TECHNICAL NOTE

Project name **Stockport Interchange**
Project no. **1620008272**
Client **Willmott Dixon Construction Limited**
Memo no. **14113-RAM-SKZ-ZZ-TN-Y3-00002**
Version **Draft**
To **Gareth Blunden, WDC**
From **Niall Meyers**
Copy to

Prepared by **James Wherrett**
Checked by **Tim Clifford**
Approved by **Simon Miller**
Description **Supplementary Ground investigation Summary**

Date 09/10/2020

Figure 1 - Daw Bank Retaining Wall profiles.

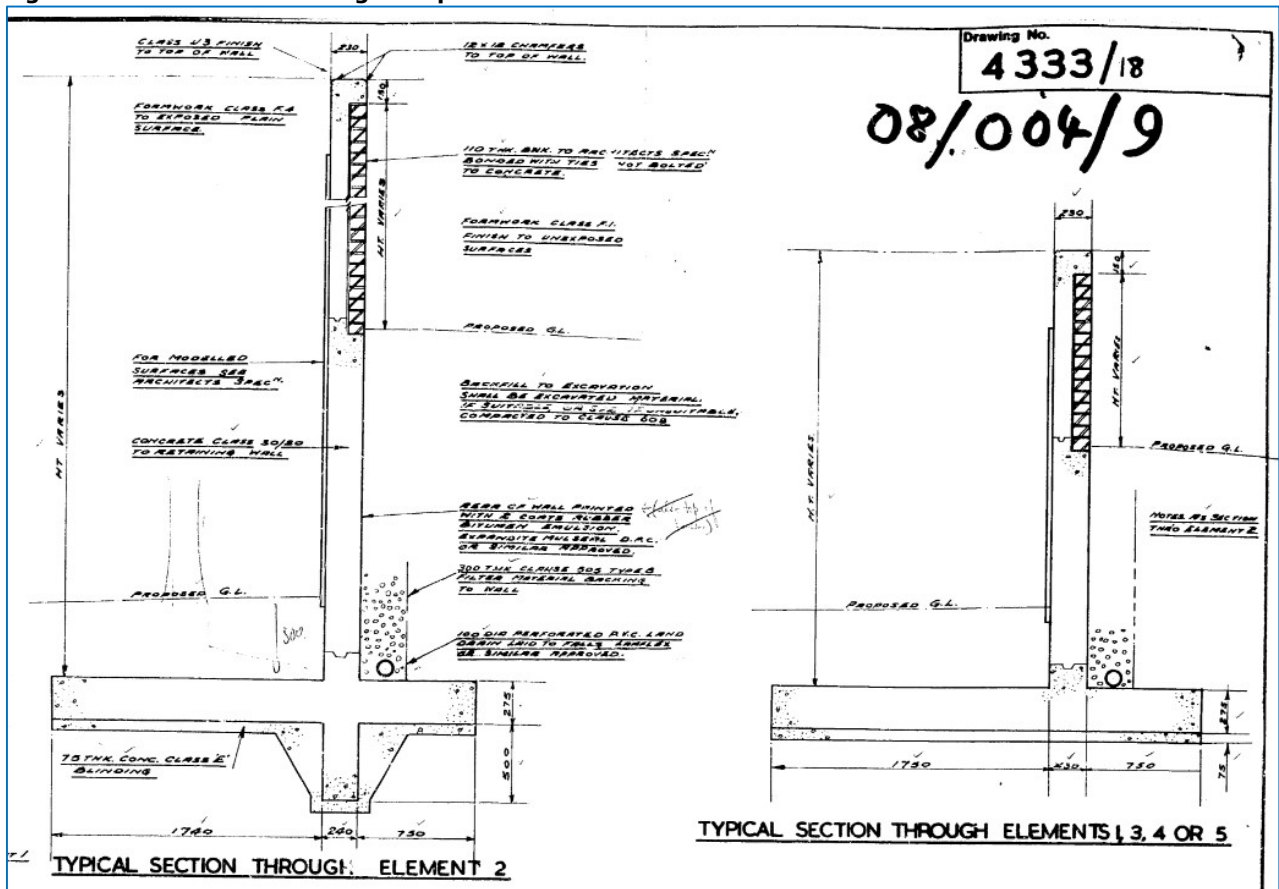
The current WSP Stage 3 design envisages that DBRW would remain intact for the section of works adjacent to the Residential tower to provide support to the footpath on Daw Bank during the construction phase. For a section of DBRW, WSP have proposed that a contiguous pile wall be constructed to support DBRW during the construction phase. The WSP geotechnical reports do not assess the stability of DBRW during the demolition or construction phase when the passive soil mass has been removed from the toe of the wall.

RUK and WDC considered that DBRW required further investigation to confirm the accuracy of the drawings provided and to assess the founding conditions. The ground information provided to date inferred that DBRW was founded on Made Ground. The information is required to permit an assessment of the stability of DBRW.

A preliminary stability assessment has been undertaken assuming Rankine earth pressures based on an existing retained height of $\sim 1.4\text{m}$ and cover to the top of the DBRW toe $\sim 0.6\text{m}$. A maintenance surcharge load to the footpath of 5kPa has been adopted. Based on this assessment there is a risk that DBRA will not be Eurocode compliant if the passive ground level is reduced to the base of the retaining wall. The assessment indicates that the Factor of Safety (FoS) is greater than one though the Eurocode overdesign ratio is less than one for DA1-DC2 design case. To maintain stability the active ground level could be reduced and loads restricted on the active side of the wall. A detailed assessment will need to be undertaken assessing additional cross sections.

Figure 7 - Section S-02 from WSP drawing 14113-WSP-SKR-ZZ-DR-S-3001 taken at approximate location of BH400. Rockhead level in BH400 was not proven though is anticipated to be deeper than 38.1m OD with base of foundation at 40.8m OD.

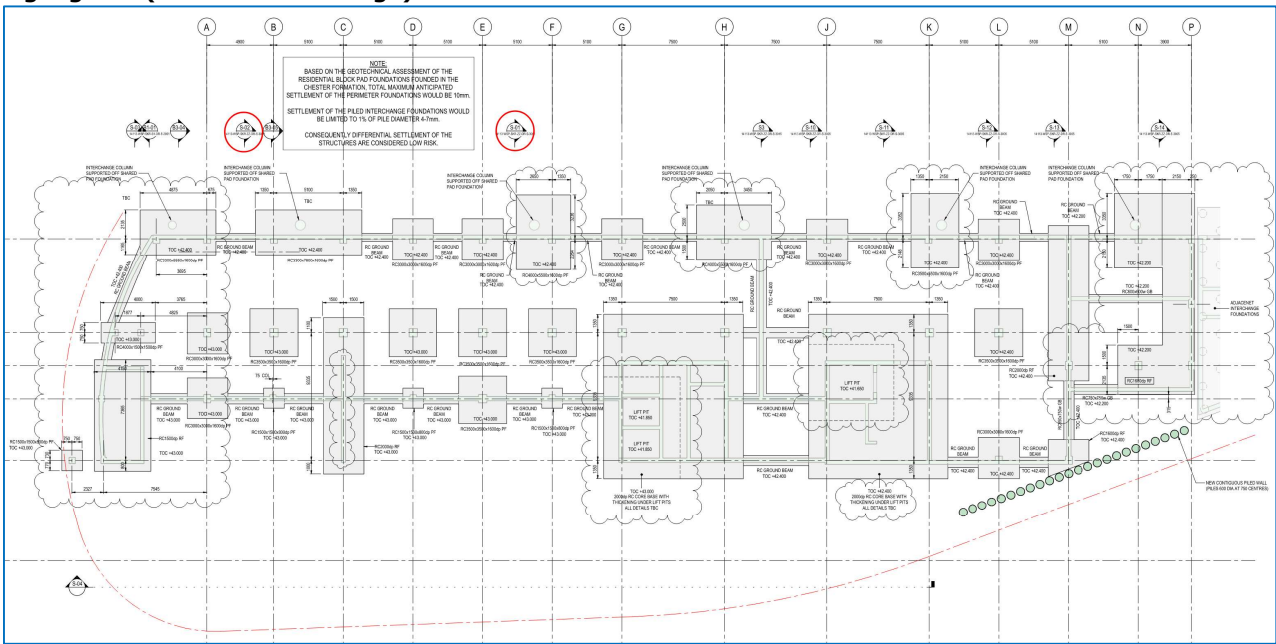
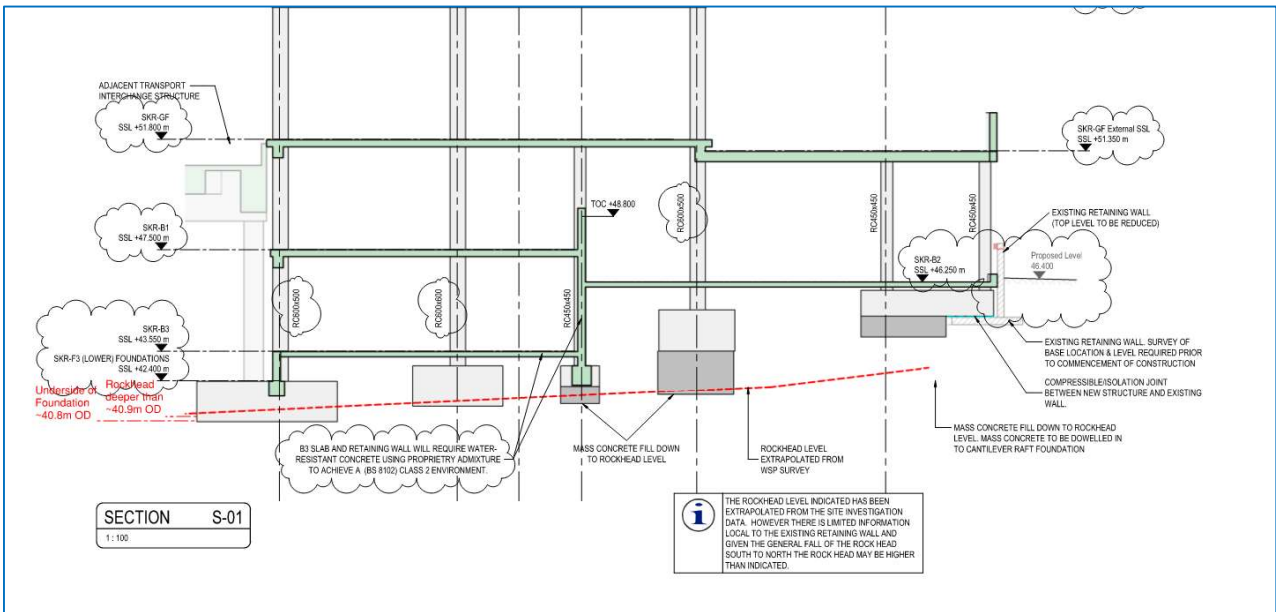
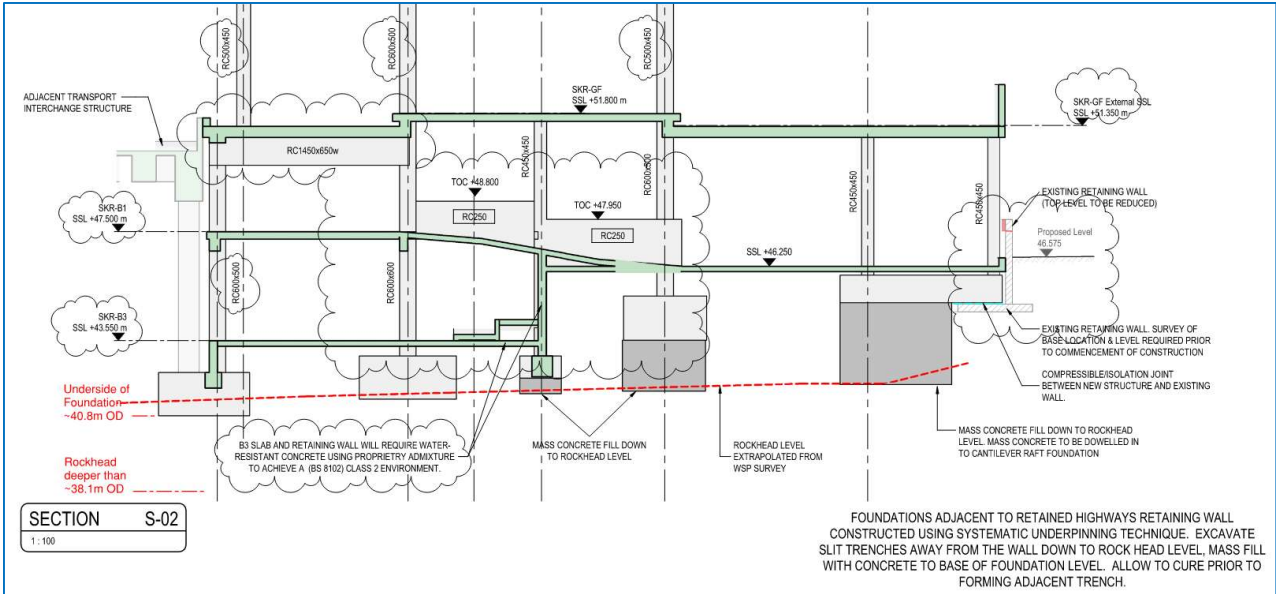
Figure 5 presents the lower foundation layout with two sections (S-01, S-02) highlighted. S-01 would intersect with the location of BH401 and S-02 would intersect with BH400. Figure 6 and Figure 7 present the sections with the depths to rockhead noted. From the sections it can be seen that the depth to rockhead in Figure 6 is close to that predicted by WSP. However, in Figure 7, it can be seen that rockhead has been interpreted as not encountered. The founding soils at that location could not be confirmed due to the poor recovery.

Based on the information from the supplementary ground investigation, Ramboll considers that the WSP Stage 3 proposed shallow foundation solution in the vicinity of BH400 is not viable without some form of ground treatment. This would most likely require the excavation of all unsuitable materials under the footprint of each foundation affected and replace with a lean mix concrete.

The extent of unsuitable materials cannot be determined at this stage without extensive additional ground investigation, which is unlikely given the operational requirements of the bus station, and this therefore represents a significant risk to the project. It is therefore recommended that one additional cable percussion borehole is advanced next to BH400 to confirm the depth to bedrock and the geological profile. The CP drilling method will allow full recovery and profiling of the soil at this location. This can then confirm that the shallow foundation solution is invalid without some form of ground treatment. There is a small though not insignificant risk that the superficial deposits are anthropogenic in nature and may present a contamination risk (potential cellar for instance). The CP borehole will permit sampling for environmental purposes and allow for the potential installation of a monitoring well for groundwater and ground gas if required.

The Stage 3 WSP design drawings state that the shallow foundations supporting the southern podium require underpinning. The note on the cross-section drawing (Figure 7) states the following:

Foundations adjacent to retained highways retaining wall constructed using systematic underpinning technique. Excavate slit trenches away from the wall down to rock head level, mass fill with concrete to base of foundation level. Allow to cure prior to forming adjacent trench.

Given the granular nature of the made ground materials underlying DBRW, it is considered that the proposed slit trenches are at risk of collapse during excavation and would most likely require trench shields. These would not prevent collapse of materials on the short side of the slit trench that could lead to undermining of DBRW. Undermining of DBRW will decrease the stability further and would need further assessment once the geometry of the slit trench is confirmed. WSP have also noted that piled foundations may be adopted if underpinning the foundations is not considered viable.

Figure 10 - Pile and Pile cap layout over sewer and adjacent to the A6 Viaduct. (14113-WSP-SKZ-F1-DR-S-2040)

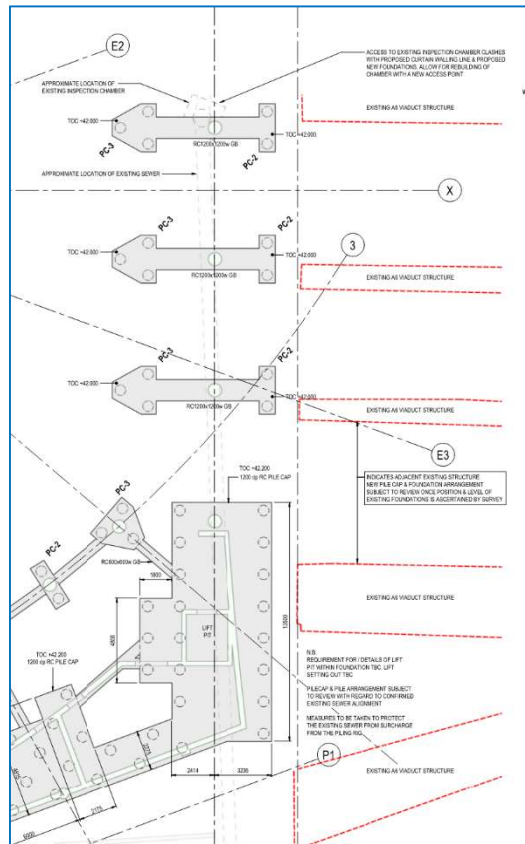
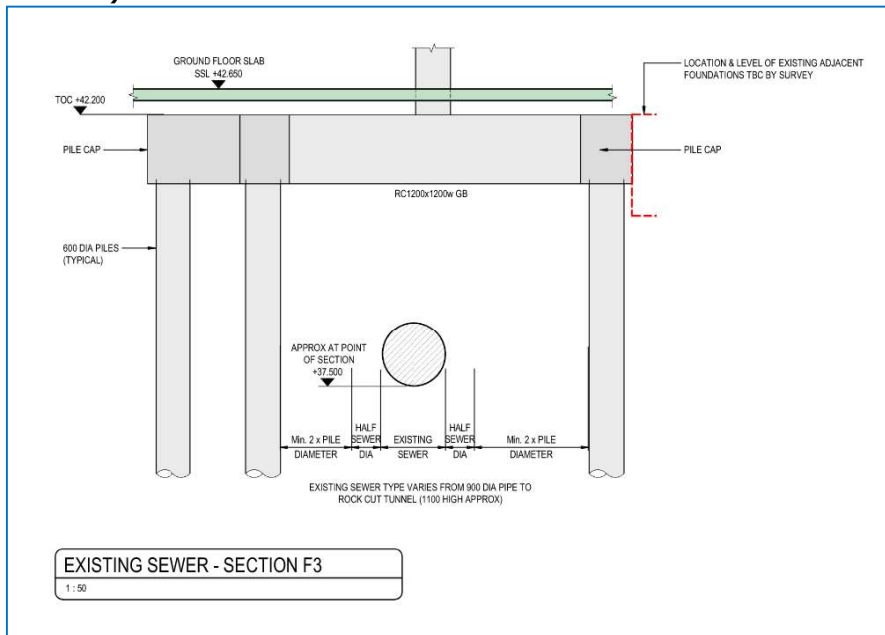
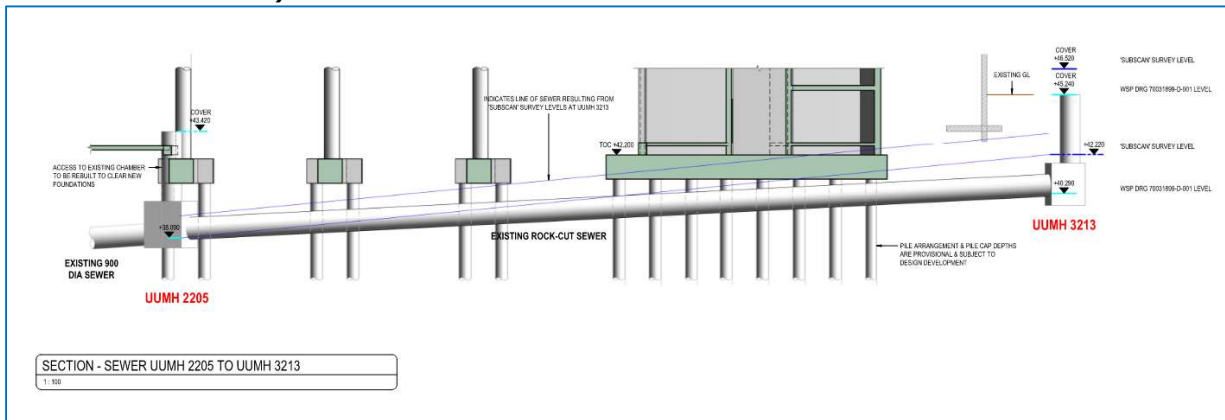
WSP have provided offset guidance from the rock cut sewer and rely on the pile caps being cast against the A6 Viaduct foundations to achieve the offset. From the available information, it appears that the sewer runs closer to the A6 Viaduct than the drawings show. The alignment and elevation of the sewer needs to be confirmed before the WSP Stage 3 foundation solution can be validated for the area.

Also of concern is the profile of the A6 Viaduct foundations. The handpits excavated to assess the foundation profile below ground infer that it projects up to 1.0m from the face of the above ground pier. It is unclear where the hand pits were excavated at this stage and further information is currently being sought from Geotechnics. However, it can be inferred that the projection will inhibit the installation of the piled foundations and the construction of the pile caps.
